Re: Objection to Development Application SSD 16_7919 – 85 Carabella Street, Kirribilli

TRANPLAN Consulting has been engaged by the local residents of 111 Carabella Street, Kirribilli to consider & respond to the Department on their behalf in respect of Development Application **SSD 16_7919** at **85 Carabella Street, Kirribilli** for the **Staged development application for a concept proposal for the redevelopment of the Loreto school campus in the south and east precincts, with detailed approval sought for works in the western precinct, as well as the vertical connectors and landscaping across the campus** (the development).

Figure B-3.1: Setback and building height plane controls for the R4 - High Density Residential zone, where the height limit is equal to 12m or less.

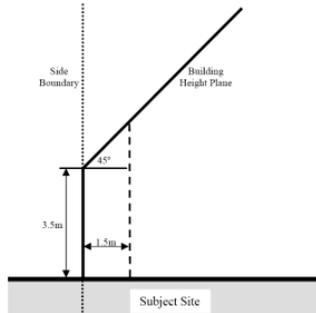
The Learning Hub does not comply with the side setback and building height plane (of 45 degrees inwards starting at 3.5m from NGL) DCP controls for the R4 High Density Residential zone and will have significant amenity impacts to the residents of 111 Carabella Street, Kirribilli in terms of loss of privacy, views, ventilation and daylight.

Figure 1 – Before & After from W21 on View Analysis plans*

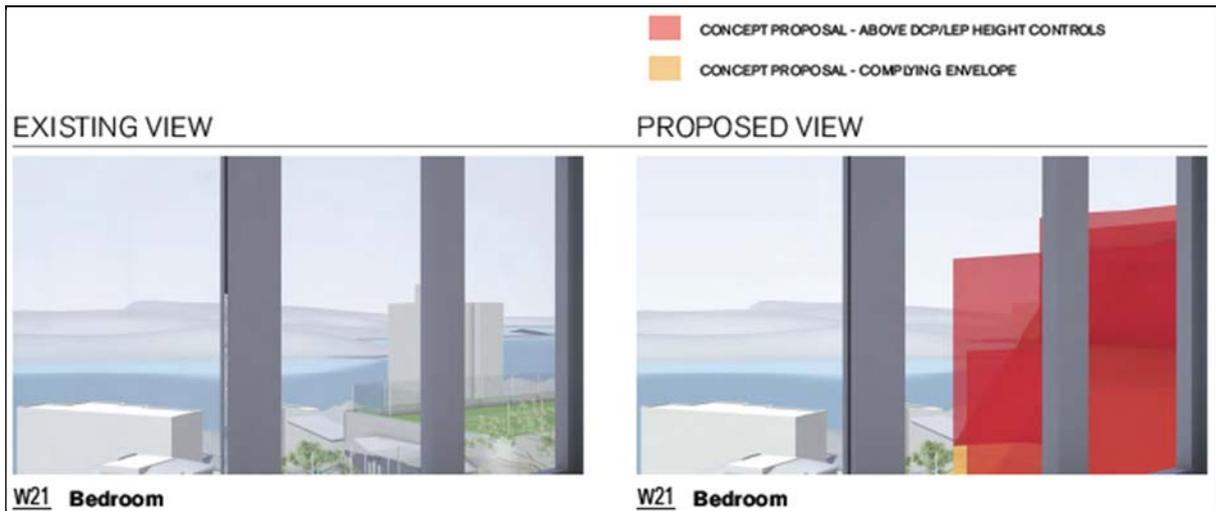
*Note the significant impact of the non-compliant proposal; about a 50% reduction of views

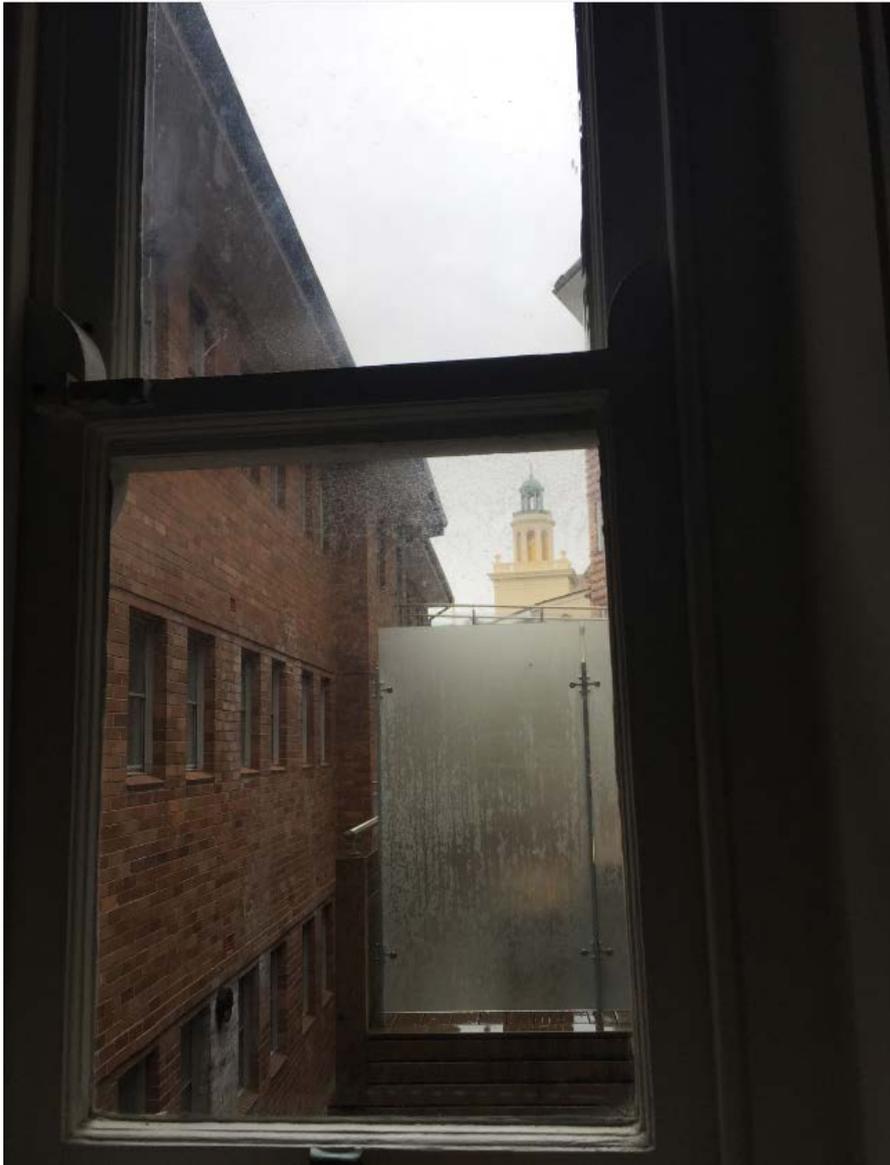
Note: In this case, the northern neighbours at 111 Carabella Street are concerned with loss of daylight rather than sunlight. It is considered that the applicability of the planning principles are interchangeable between daylight and/or sunlight.

There is a reasonable expectation that development will comply with planning legislation and controls to ensure that the neighbour's and their internal living areas & private open space will retain as much daylight as possible.

The development's non-compliant bulk/scale is poorly designed, and will result in significant loss of existing daylight for the neighbours, with the deterioration amplified towards the lower apartments.
